CITY OF MOUNTAIN VIEW  
MOUNTAIN VIEW, CALIFORNIA  
ADDENDUM NO. 1  
TO CONTRACT DOCUMENTS AND SPECIFICATIONS  
FOR  
FIRE STATION NO. 5, PROJECT 09-32

**CITY OF MOUNTAIN VIEW**  
**MOUNTAIN VIEW, CALIFORNIA**  
**ADDENDUM NO. 1**  
**TO CONTRACT DOCUMENTS AND SPECIFICATIONS**  
**FOR**  
**FIRE STATION NO. 5, PROJECT 09-32**

## MOUNTAIN VIEW FIRE STATION No. 5

Sketch Number: #ESK-2

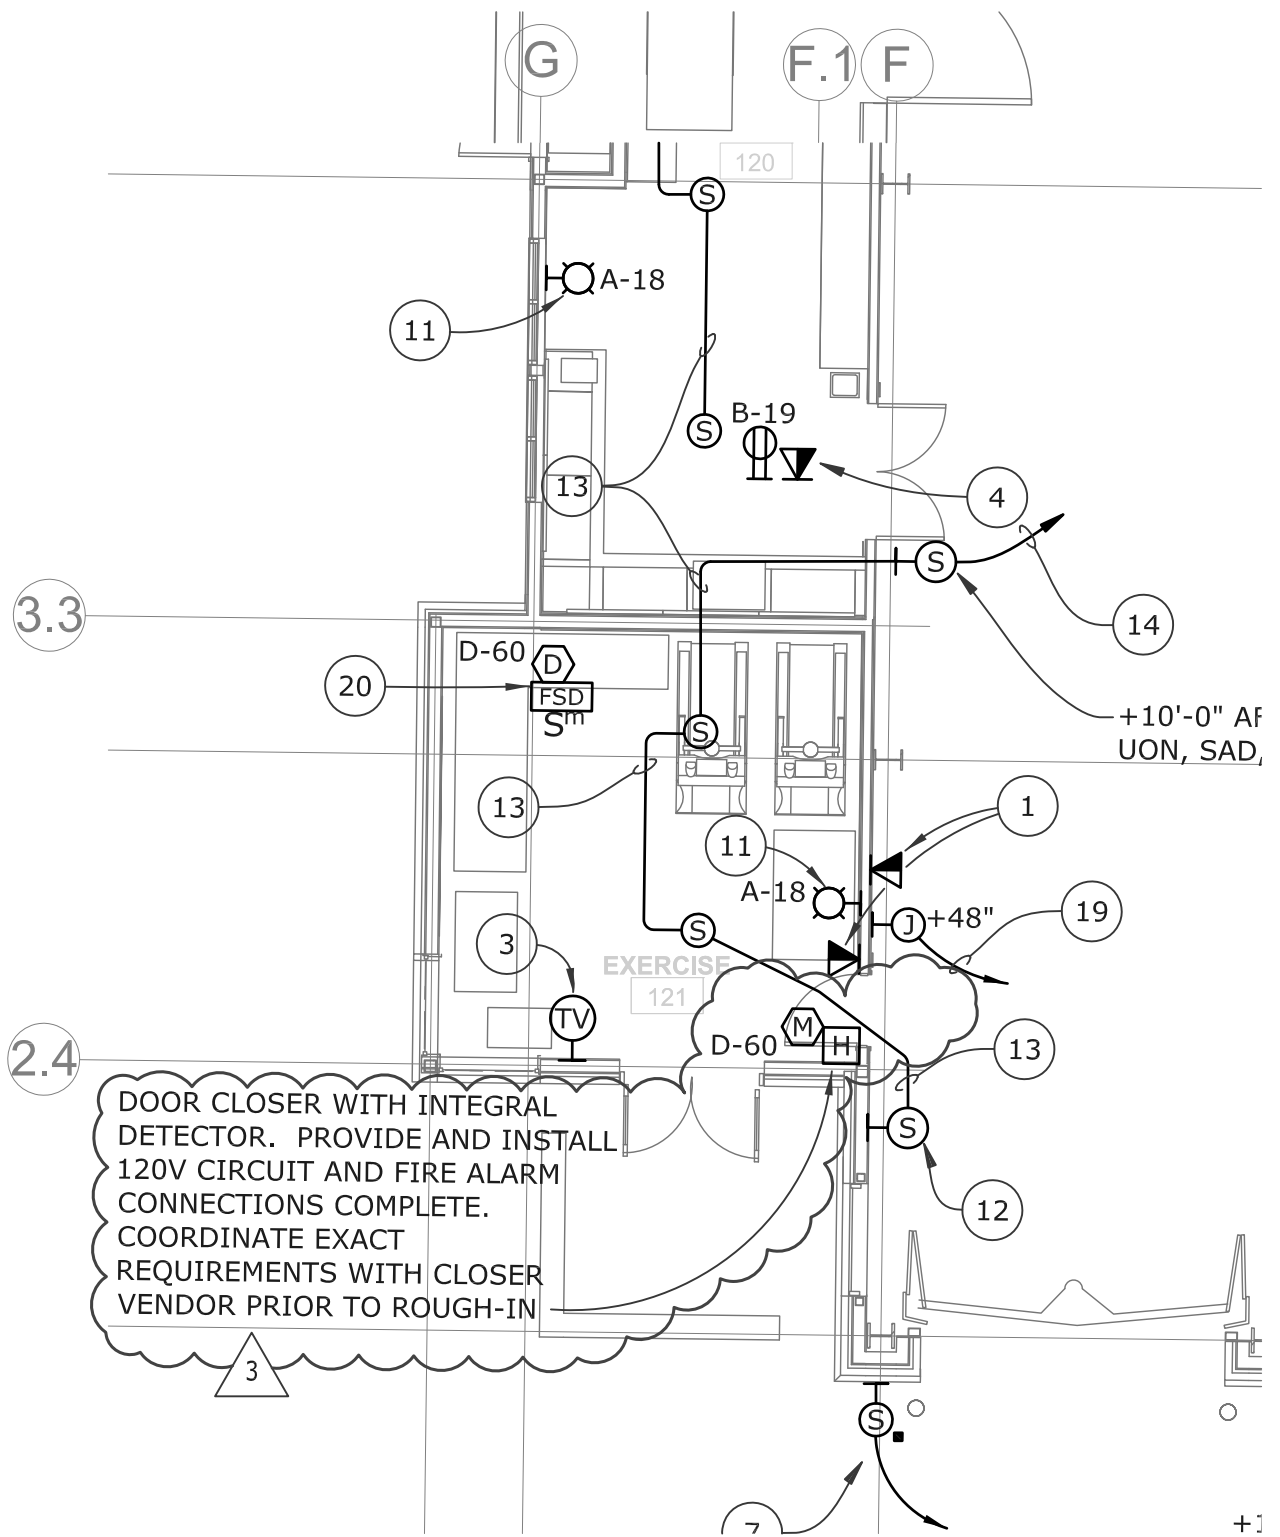
Sketch ESK-2: Revise Fire Alarm smoke detectors for door holder to be integral to door closer.

Note to Set 105; connect Smoke Closer to power supply and Fire Alarm System and described on ESK-2. The integrated hold open device shall be included in the Fire Alarm deferred submittal for approval by the fire department.

Sketch Number: #ESK-3

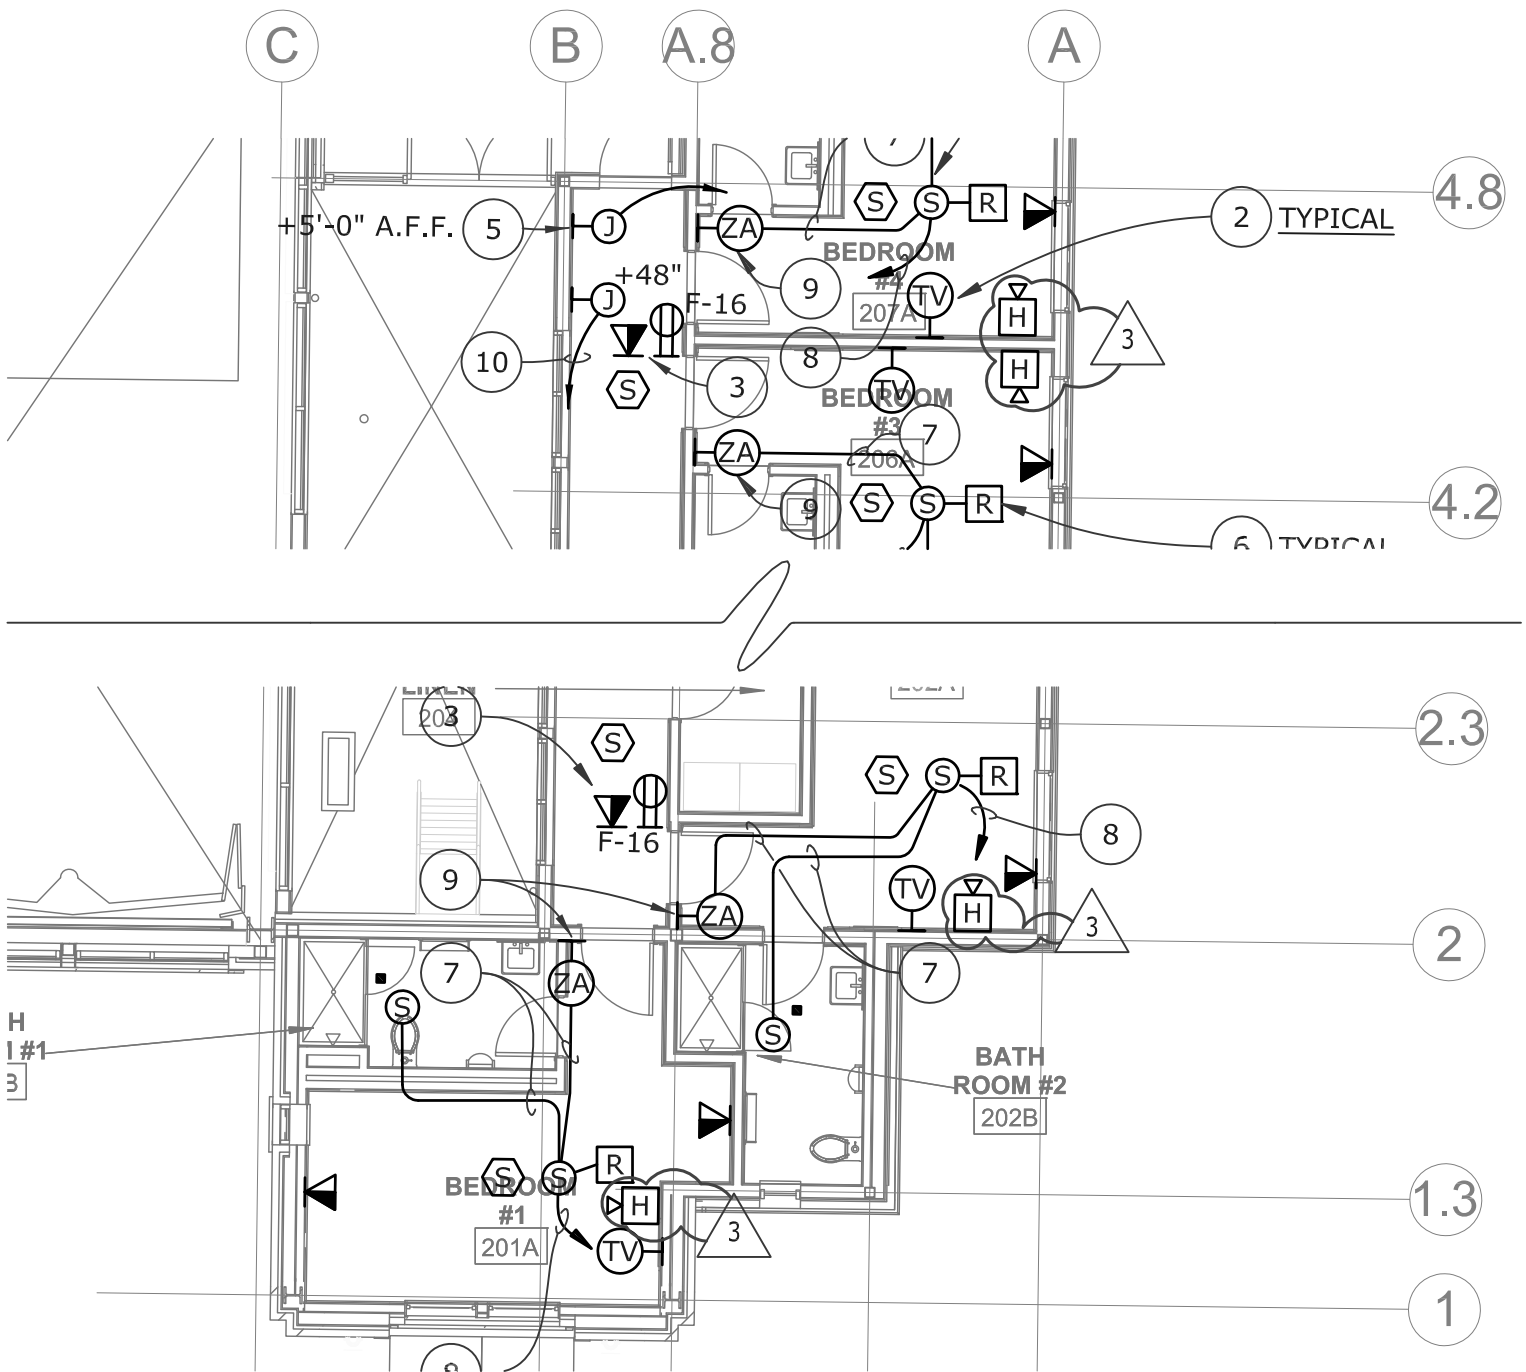
Sketch ESK-3: Revise Fire Alarm horn/strobes to horns only.
